REQUESTS FOR INFORMATION

THE NEWFOUNDLAND AND LABRADOR PUBLIC UTILITIES BOARD

GRK-NLH-93 to GRK-NLH-133

GRAND RIVERKEEPER LABRADOR INC. (GRK)

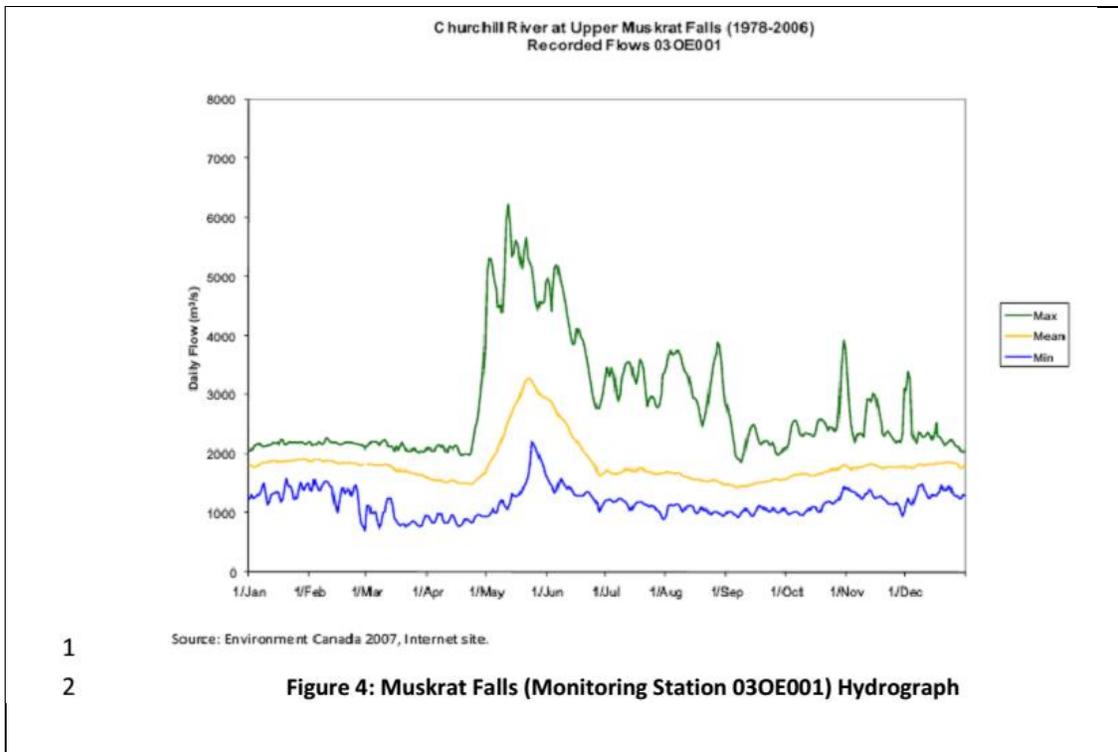
The description of the need for and the operation of the Water Management Agreement set out in Citation 3 is based on Nalcor’s understanding of Hydro-Quebec’s rights after renewal, which are contested by Hydro-Quebec.

Please explain in detail how the Water Management Agreement would operate in the event that the courts decide in favour of Hydro-Quebec’s interpretation of the Hydro-Quebec Contract and its Renewal.

Citation 2 (WMA Application, Figure 4, page 16):

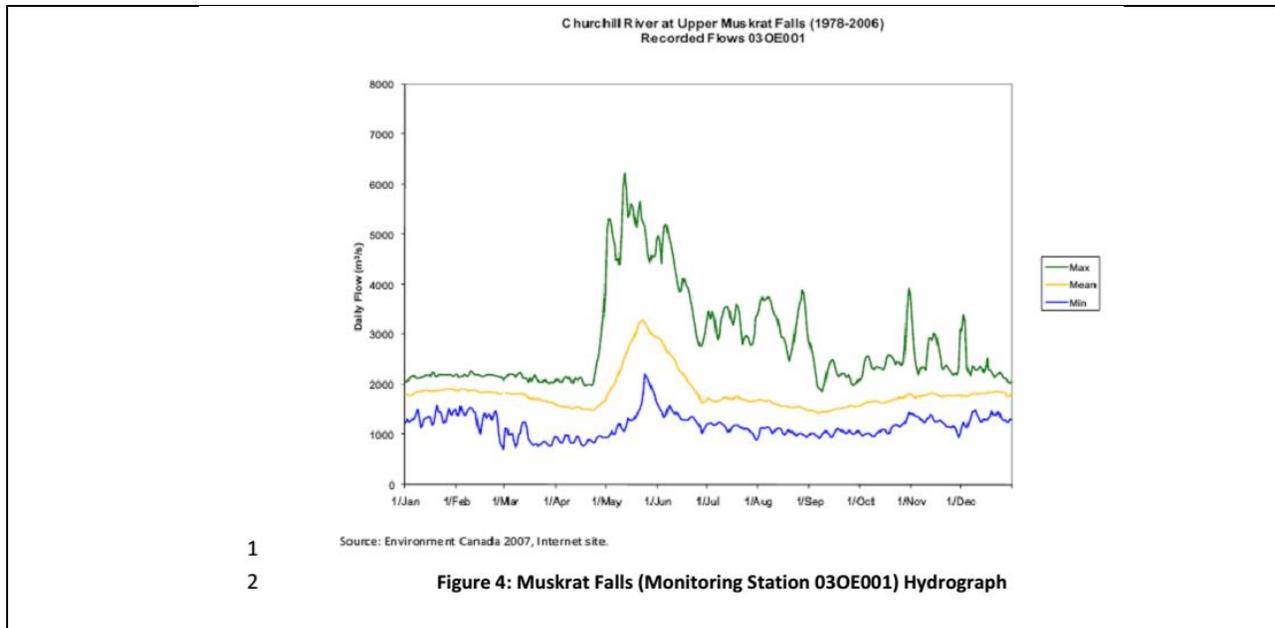
Figure 4 in Citation 2 shows that, in some years, flows on the Churchill River at Upper Muskrat Falls exceed 2,660 m³/s throughout the summer.

Please indicate the amount of spillage from Muskrat Falls in a year in which flows on the Churchill River at Upper Muskrat Falls equal those shown in the upper line of Figure 4.
